## Product Service Bulletin

**SUBJECT:** TORQUE CONVERTER CLUTCH (TCC) CHUGGLE/HUNTING CONDITION

**MODELS:** 1989-1995 GEO TRACKER, CAMI VITARA, SUZUKI SIDEKICK  
WITH HYDRA-MATIC 3L30 AUTOMATIC TRANSMISSION

**SUBJECT:** MODIFICATION OF ENGINE CONTROL MODULE (ECM)  
**MODEL:** SIDEKICK 2-DOOR WITH GM 3-SPEED AUTOMATIC TRANSMISSION  
**YEAR:** 1995 AND LATER

**Figure 1**

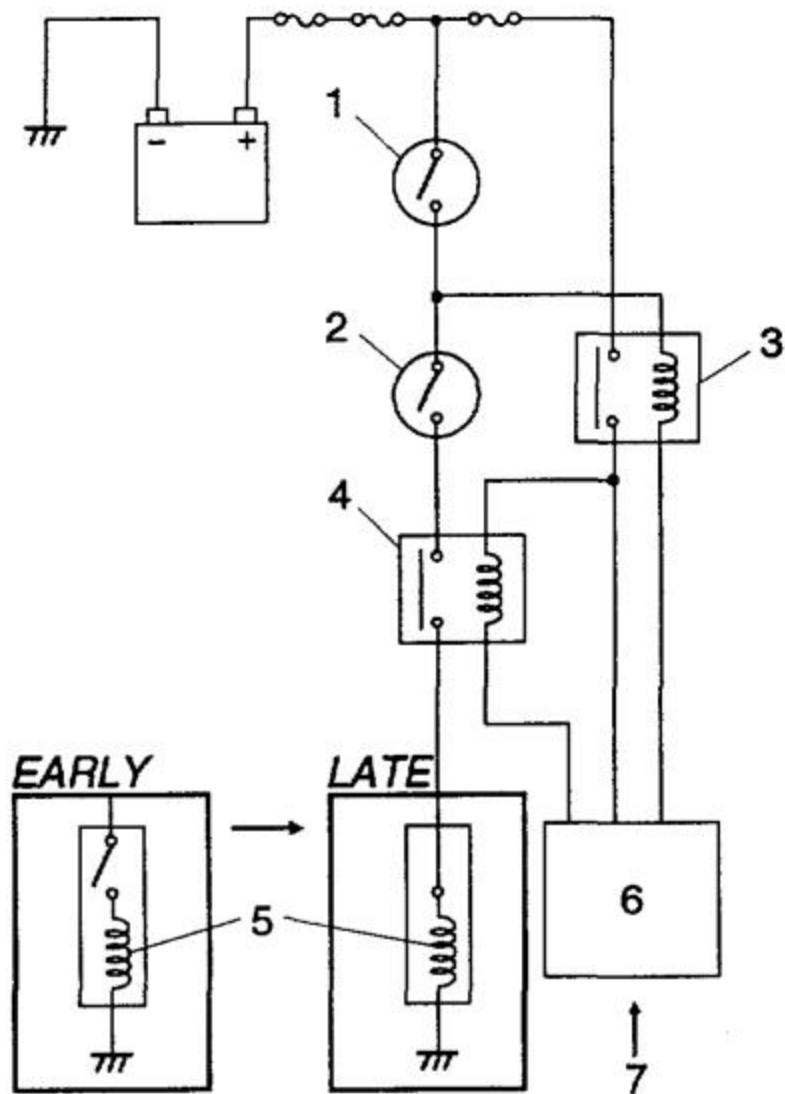
This system controls the TCC relay, one of the components that controls the torque converter clutch. A circuit diagram of this system is shown in Figure 1.

For diagnostic procedure, please refer to Technical Service Bulletin #TS 3-25. Also note that the continuity check between ① pin of TCC relay coupler and ground is not needed due to the elimination of the A/T oil pressure switch.

1. Automatic transmission assembly
2. Second brake accumulator No. 2 spring
3. Second brake accumulator No. 1 spring
4. Piston/spring set
5. Forward clutch assembly
6. Forward clutch plate set
7. Retaining ring
8. Second brake accumulator piston
9. Second brake accumulator

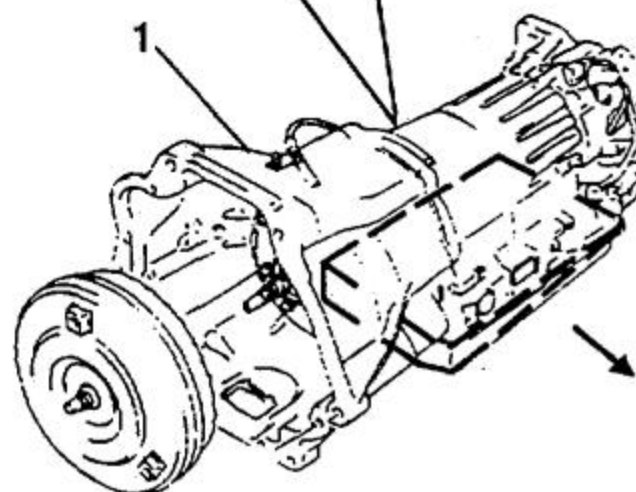
This bulletin is to inform you of the modification of the inner parts for the 4-Speed Automatic Transmission which has been carried out since January 1997 production. The modifications listed in this bulletin were introduced to reduce gear shift shock when shifting from Neutral to Drive, Neutral to Reverse, and First to Second gears. When rebuilding the transmission, please use the parts as listed in this bulletin.

REF. NO.	PART NAME	SPRING LENGTH ("L"), SPRING ID COLOR, AND PISTON TYPE							
						EARLY		LATE	
		①	②	③	①				
2	Second brake accumulator No. 2 spring	2.172 in. (55.18 mm) (Light Green)	→	2.211 in. (56.16 mm) (Purple) *	→	2.220 in. (56.40 mm) (Green)	→	2.172 in. (55.18 mm) (Light Green)	
3	Second brake accumulator No. 1 spring	1.383 in. (35.13 mm) (Red)	→	0.728 in. (18.50 mm) (Purple) *	→	0.689 in. (17.50 mm) (Red)	→	1.383 in. (35.13 mm) (Red)	
8	Second brake accumulator piston	Type 2	→	Type 1 *	→	Type 1 *	→	Type 2	
AT Serial Number		To 95DQ61560 or 95HQ61360	From 95DQ61561 to 96MQ65010 or from 95HQ61361 to 96MQ65405				From 96MQ65011 or 96MQ65406
